Our reference: P-354804-H3G2
Contact: Kathryn Saunders
Telephone: (02) 4732 8567

Aspect Industrial Estate Modification 2 – SSD 10448 Proposed Mod-2

Aspect Industrial Estate – SSD-10448 - MOD1 – Environmental Assessment Report

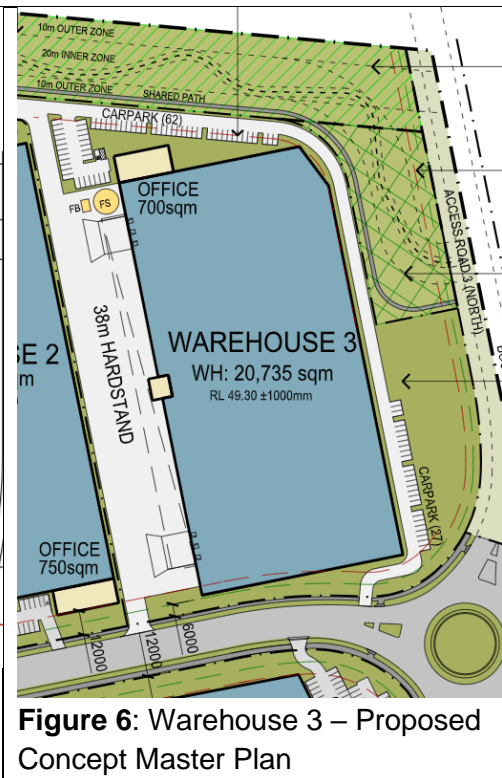
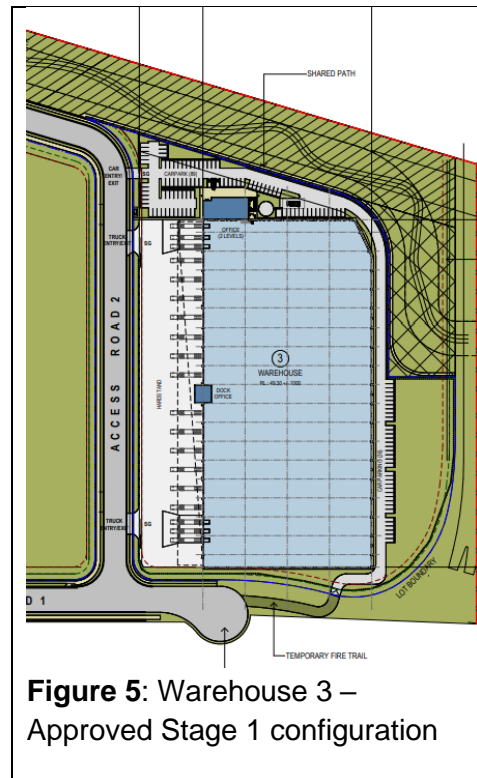
- (a) The ultimate vehicular arrangements proposed for Warehouse 3 remain unclear.

The approved Stage 1 and Concept master plan provided heavy vehicle entry/access directly to Warehouse 3 from a public road as per **Figure 5** below. The new vehicle entry/access arrangement for Warehouse 3 are as per **Figure 6** below.

The concept plans indicate that no right turn into the staff and visitor driveway will be available owing to the location of the roundabout pedestrian safety refuge.

The 27 staff parking areas located along the eastern side of Warehouse 3 are too far removed from the entry point for workers. And no safe separated pedestrian pathway is provided along the private driveway.

No safe pedestrian pathway is provided for staff and visitors along the northern private driveway for Warehouse 3.

The EIS includes that a future, adjusted version of the architectural plans will include a 1.5m wide pedestrian pathway that will facilitate safe travel from the carpark to the office, separated from the roadway. It is recommended that DPE seek submission of this plan and that it forms part of the approved documents, should consent be granted.

Figure 7: Applicant's Landscape plan – Warehouse 1 – 05 refers to Spotted Gums

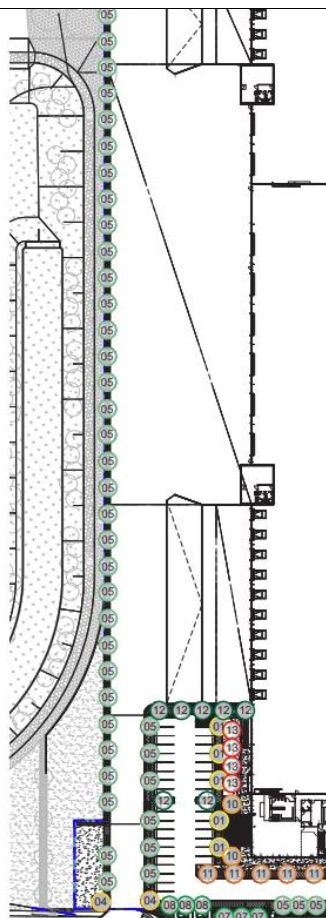
Spotted Gums shown on the Tree Planting Masterplan S1-1 001 Rev A are not indicated on the Lot 1 on-lot works landscape plans (refer S1-1_101 through 103 revision P and **Figures 7 & 8** below).

Notwithstanding the above, trees are not achievable in the selected location upon review of the sections and owing to the location of the palisade fencing, the retaining wall, and the super awning above.

Figure 9: Civil plans indicating no space for canopy tree planting (refer 18-596-C2143 issue I)

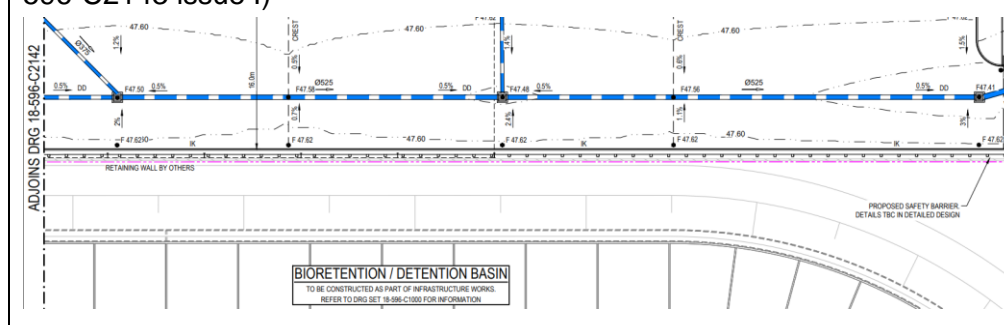
Council strongly recommends that DPE require that the Aspect precinct achieve compliance with the minimum 10% canopy tree targets as is required under the Mamre Road Precinct DCP.

Canopy trees previously approved in the Estate are significantly reduced by the amended plans which is not supported by Council. The resultant presentation of Warehouse 1 to Mamre Road is to be addressed and improved. The warehouse footprint is to be reduced to enable the provision of canopy trees, shrubs and along this elevation.

Figure 3: Excerpt from Proposed Landscape Plan showing awning line over trees

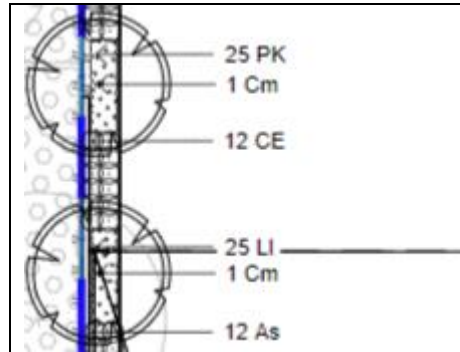
- The location of the super awning for Warehouse 1 will not enable canopy to mature. The proposed landscape plans nominate Spotted Gums which have a 30m mature height and a minimum 8m width. The Spotted Gums are proposed to be located between the basin and the warehouse awning edge which is not sustainable, and plans show that the super awning spans over the trees and that retaining wall RW11 (max. height of 2.5m) is also located on this boundary.

Figure 6: Excerpt from amended Landscape Masterplan indicating no canopy trees planted along western boundary of Warehouse 1.

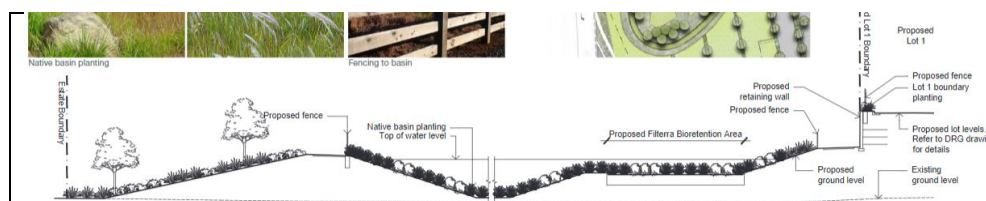
In addition, the proposed Landscape Masterplan indicates that no trees are proposed in this same location see Figure 6.

The resultant presentation of this elevation to Mamre Road is to be addressed.
